re: Geotechnical Grading and Site Servicing Plans Review
Proposed Industrial Development
295 Roger Neilson Way - Ottawa, Ontario

date: August 27, 2026

file: PG7845-MEMO.02

FIGURE 1

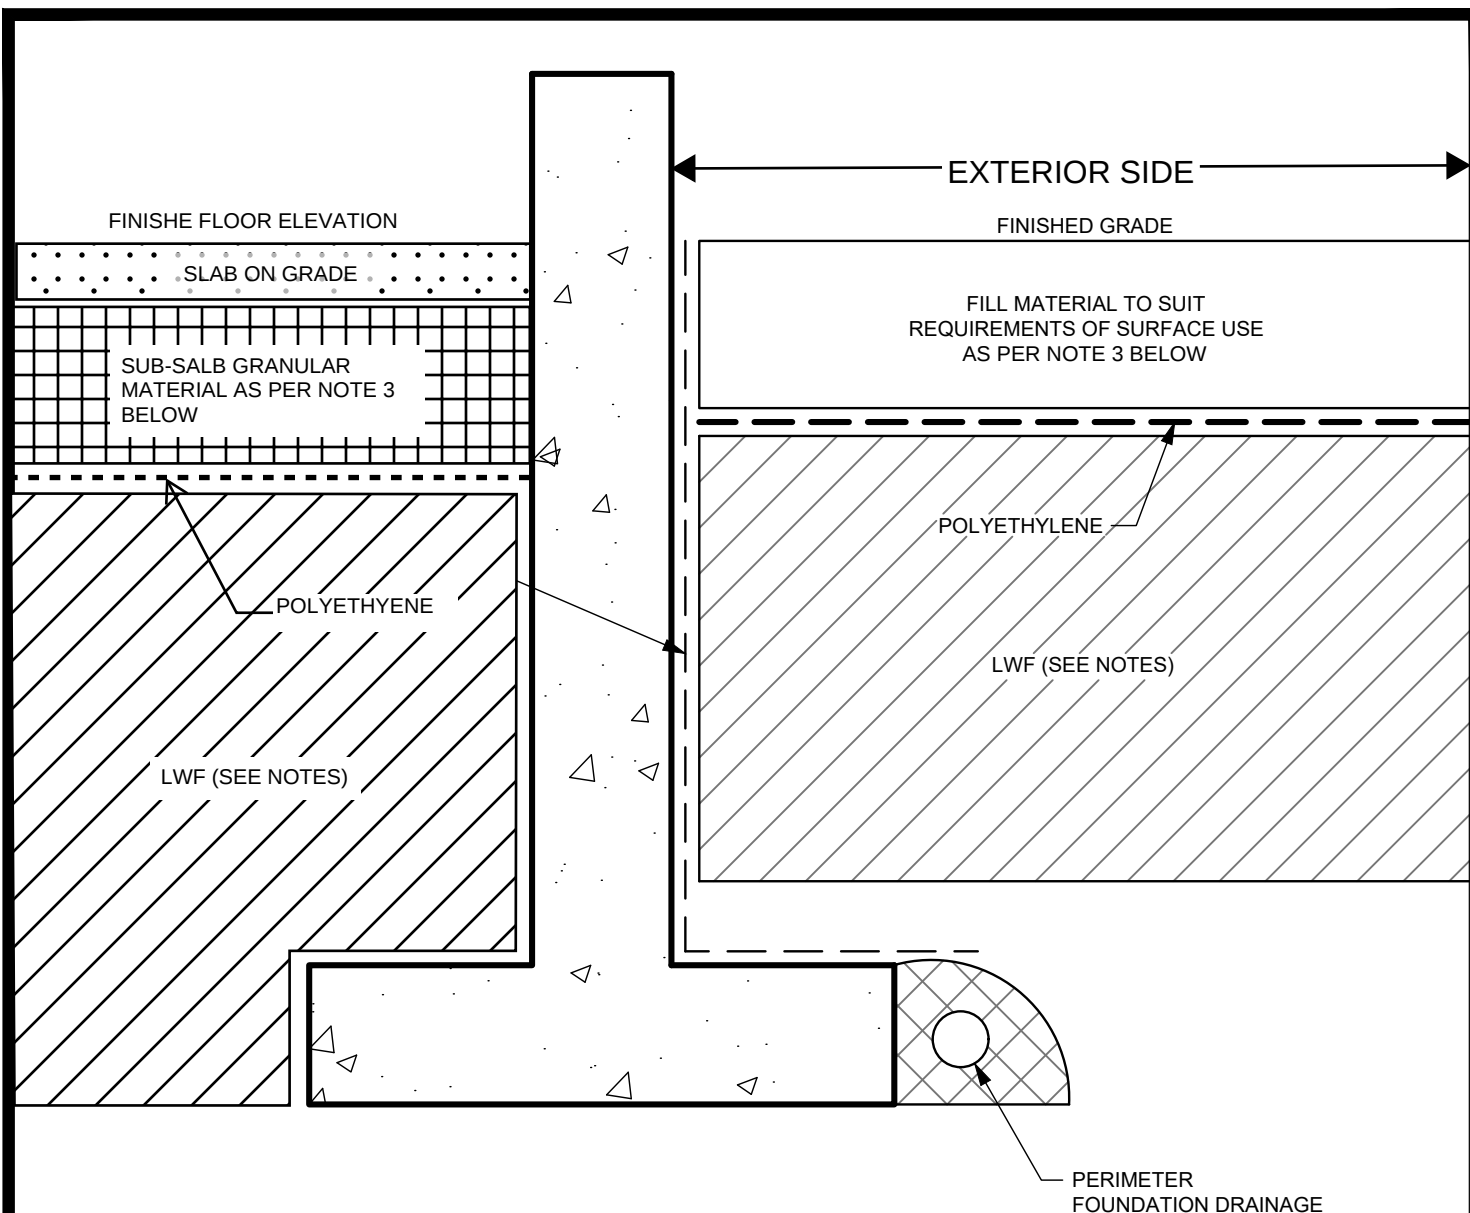
Reference should be made to Figure 1 – EPS Block Installation Recommendations and Figure 2 – Marked-Up Grading Plan, which indicate the required locations, extents, and thicknesses of the LWF.

It shall be noted that the LWF shall not extend vertically below the USF. The LWF should consist of EPS (expanded polystyrene) geofoam blocks, which allow for raising the grade without adding a significant load to the underlying soils. For this application, EPS type 15 should be used.

1. USE EPS12 BELOW LANDSCAPED AREAS
2. USE EPS15 BELOW GARAGE DRIVEWAY AND INTERIOR AREA
3. MINIMUM GRANULAR THICKNESS OVER LWF SHOULD BE AS FOLLOWS:

FRONT PORCH	150mm OF OPSS GRANULAR A
GARAGE	300mm OF OPSS GRANULAR A
DRIVEWAY	450mm OF OPSS GRANULAR A
LANDSCAPED	500mm OF APPROVED BACKFILL SOIL
INTERIOR AREA	300mm OF OPSS GRANULAR A
4. PLACEMENT OF LWF SHOULD BE ON A LEVELED SURFACE (SAND CAN BE USED TO PROVIDE AN ADEQUATE LEVELLING SURFACE).

Figure 2 – Marked-Up Grading Plan

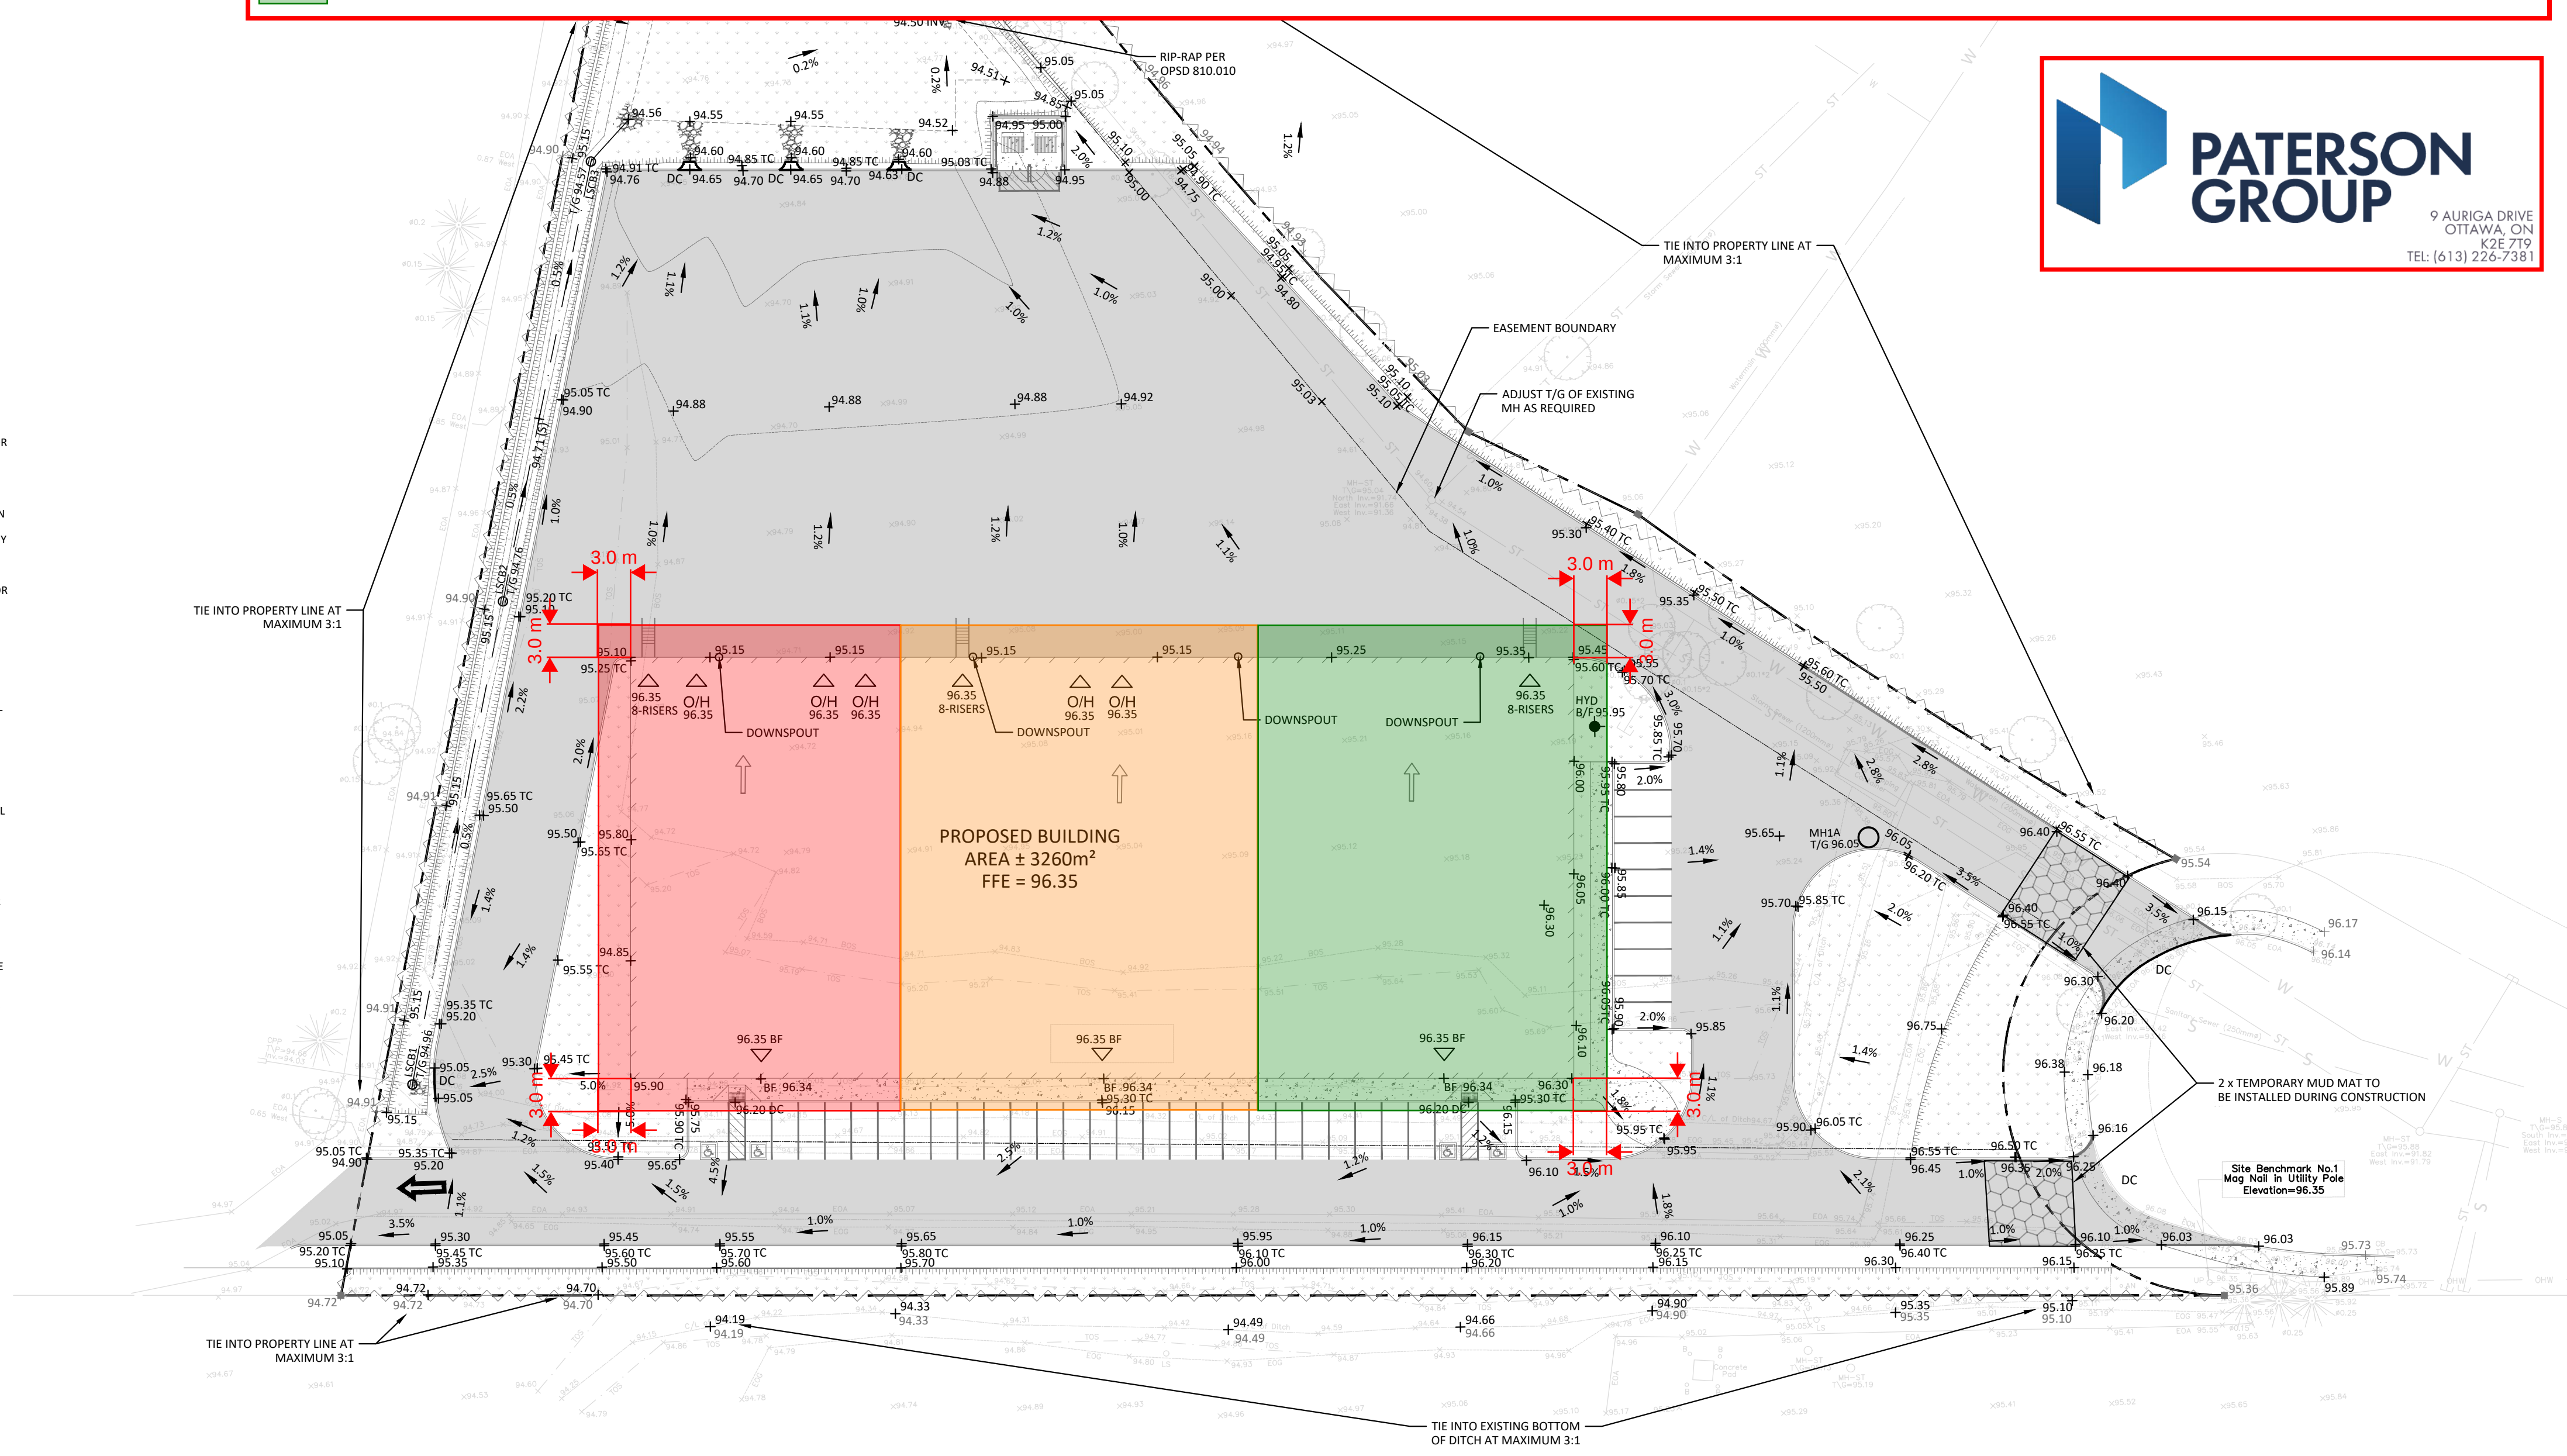
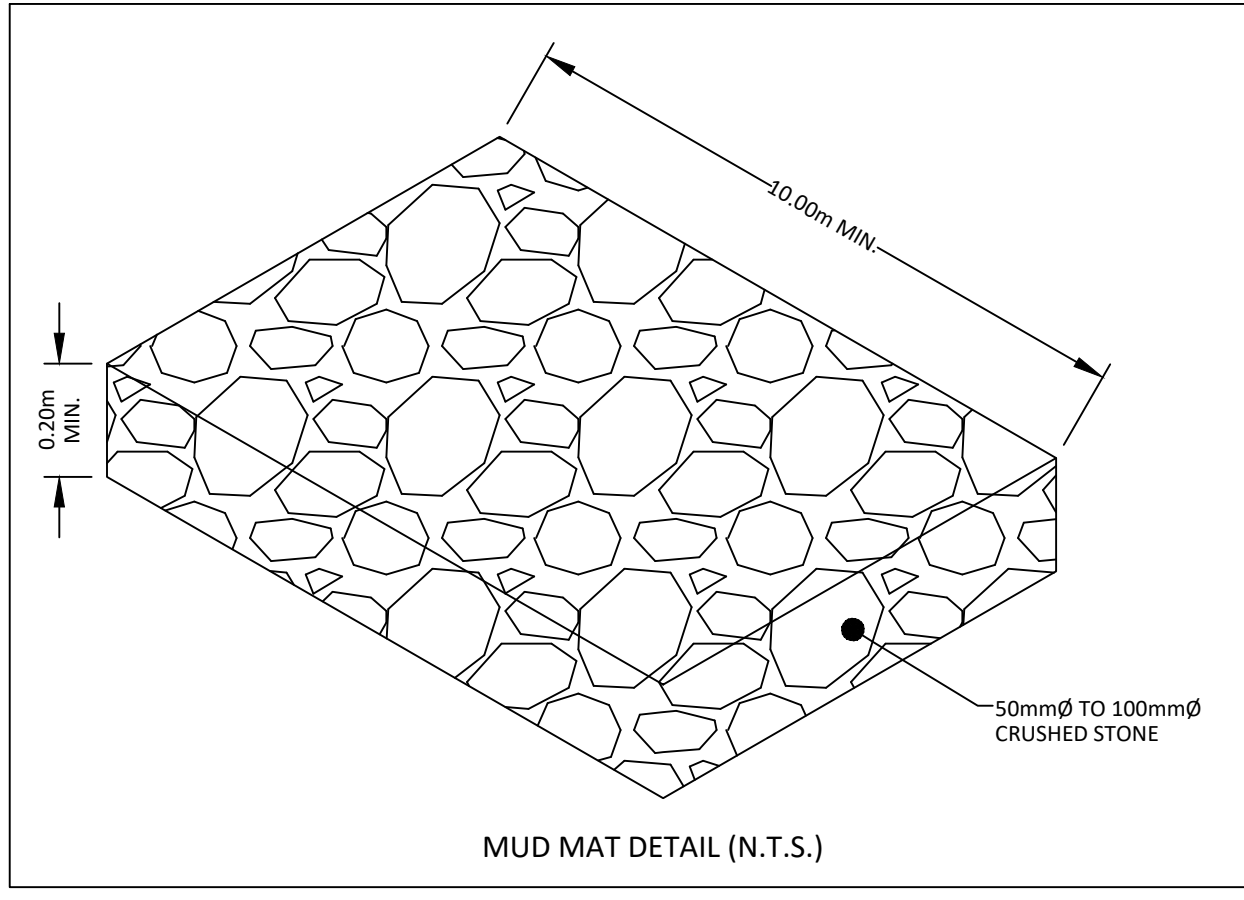
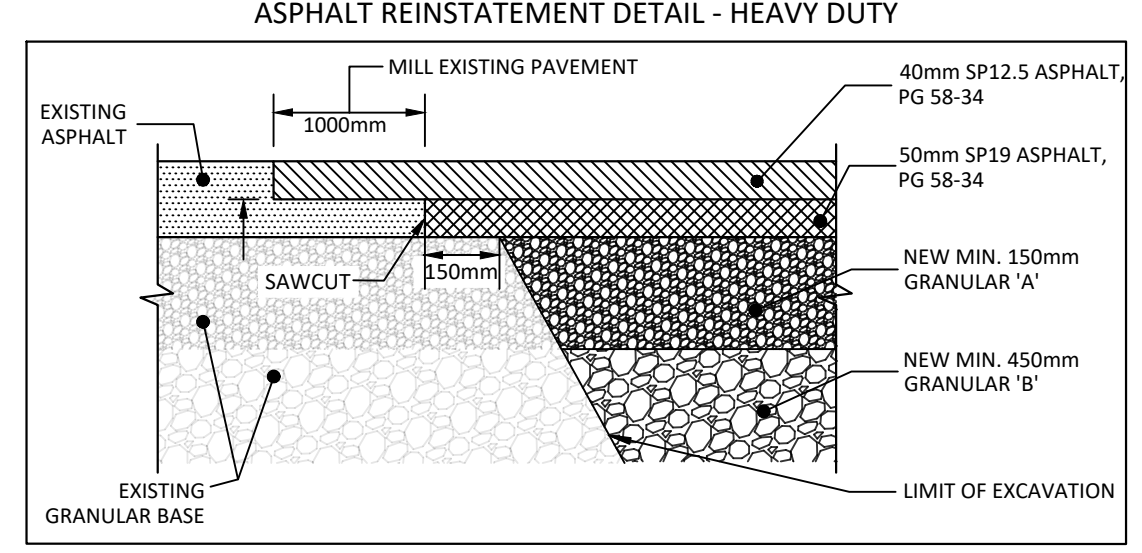
Paterson has reviewed the subsurface conditions within the footprint(s) of the proposed building. Based on our review, **a permissible grade raise restriction of 0.5 m** is recommended in the proposed building footprint and within 3 m of the building perimeter. This accounts for a live load on the slab-on-grade of 12 kPa. If the actual live load on the slab-on-grade differs from this value, then this permissible grade raise value would need to be adjusted. Beyond the 3 m distance from the proposed building perimeter, **a permissible grade raise restriction of 1.2 m** is recommended.

Based on our review of the above-noted drawing, the proposed grading for the parking areas, access roads, and landscaped areas beyond 3 m of the proposed building footprint is within the permissible 1.2 m grade raise. However, based on the finished floor elevations and proposed grading around the building, lightweight fill (LWF) should be placed below and around the proposed building footprint. The LWF should be installed at the minimum thickness, locations, and extents shown on Figure 2 attached to this memorandum.

- Minimum 1.1 m thick layer of EPS 15 geofam lightweight fill blocks should be placed and extend horizontally a minimum 3 m beyond foundation walls.
- Minimum 0.9 m thick layer of EPS 15 geofam lightweight fill blocks should be placed and extend horizontally a minimum 3 m beyond foundation walls.
- Minimum 0.7 m thick layer of EPS 15 geofam lightweight fill blocks should be placed and extend horizontally a minimum 3 m beyond foundation walls.
